FINAL RECOMMENDATION OF THE NORTHWEST DESIGN REVIEW BOARD

Project Number: 3011964
Address: 8022 15th Avenue NW
Applicant: Chris Davidson, Studio Meng Strazzara
Date of Meeting: Monday, October 10, 2011
Board Members Present: Jean Morgan (Chair)
Jerry Coburn
Mike DeLilla
David Neiman
Ted Panton
Board Members Absent: None
DPD Staff Present: Lisa Rutzick

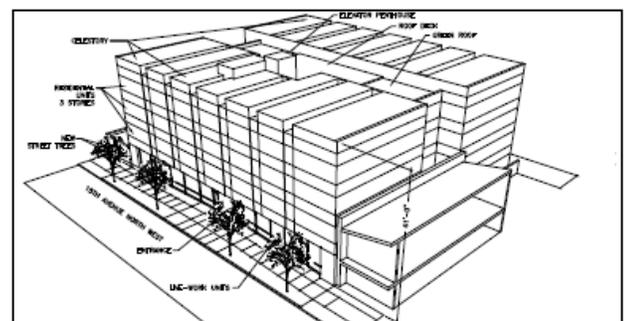
At the Final Recommendation Meeting, the Board did not discuss the inclusion of the guard rail grilles in front of sliding windows proposed for ventilation along 15th Avenue.

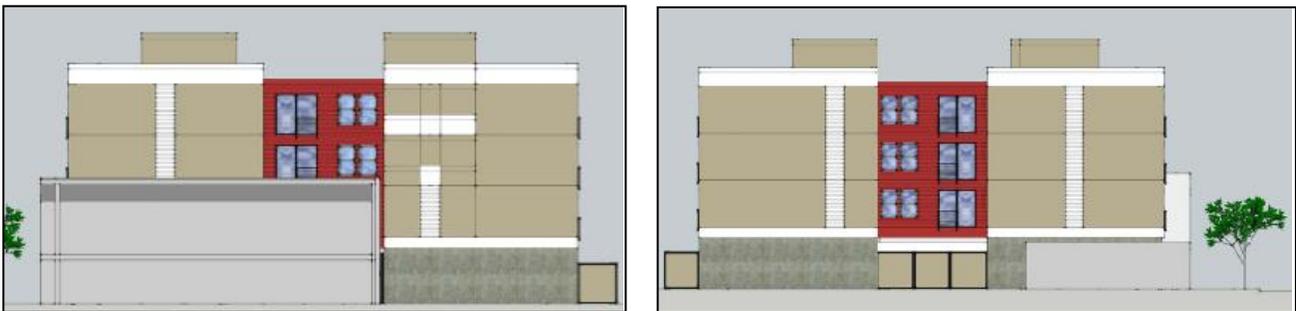
At the Final Recommendation Meeting, the Board was supportive of the building setback along 15th Avenue and the proposed dense landscaping of the planting strip and between the sidewalk and the building façade. The Board reviewed both ground level design options and settled on a hybrid – see discussion under E-1.

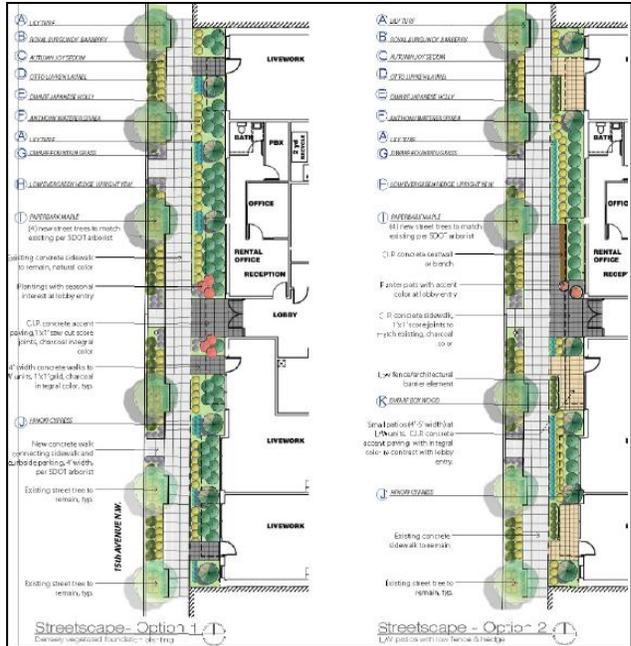
At the Final Recommendation Meeting, the Board reviewed both options for the landscaping and hardscape design for 15th Avenue and recommended a hybrid which keeps the entry designs of Option 2 (at the lobby and live/work units) with the benches and landscaping and combines that with the simple, wider pathways leading to the individual entries shown in Option 1.

The Board was satisfied with the proposed six foot tall fence at the alley. The Board agreed that the addition of green walls and screens along the alley fence would help provide visual relief and softening of proposed development in relation to the lower density zone.

4. The landscaping and hardscape design along 15th Avenue should be a hybrid which keeps the entry design of Option 2 with the benches and landscaping and combines that with the simple, wider pathways leading to the individual entries shown in Option 1. (A-2, A-3, A-4 and E-1).
